Field Replacement Guide for SMLC Hardware

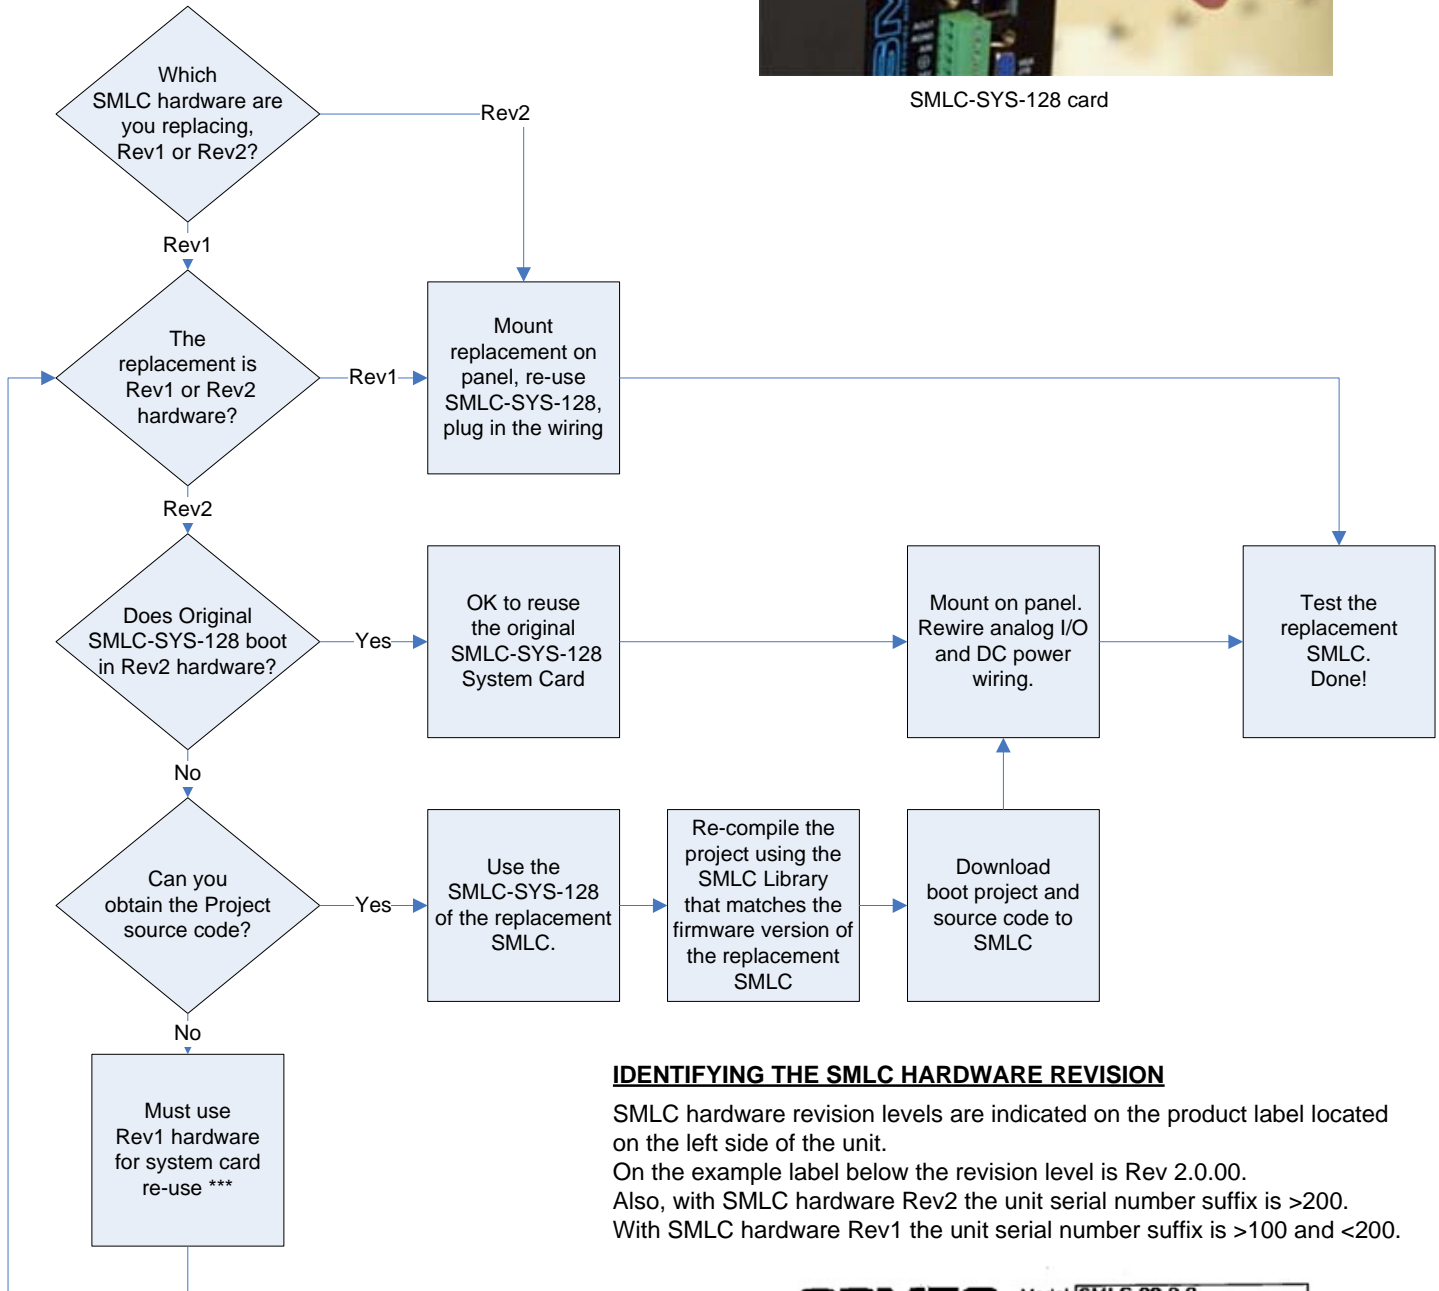
A change in SMLC Hardware Rev2 has introduced a compatibility issue, and plug-and-play reuse of the System Card may not be possible in all cases.

The flow chart below is provided as a compatibility guide to the general steps required for SMLC replacement.

*** A limited quantity of Rev1 Hardware remains available for order and is obtained by adding "-V1" to the standard SMLC part number.
Example: SMLC-80-0-0-V1
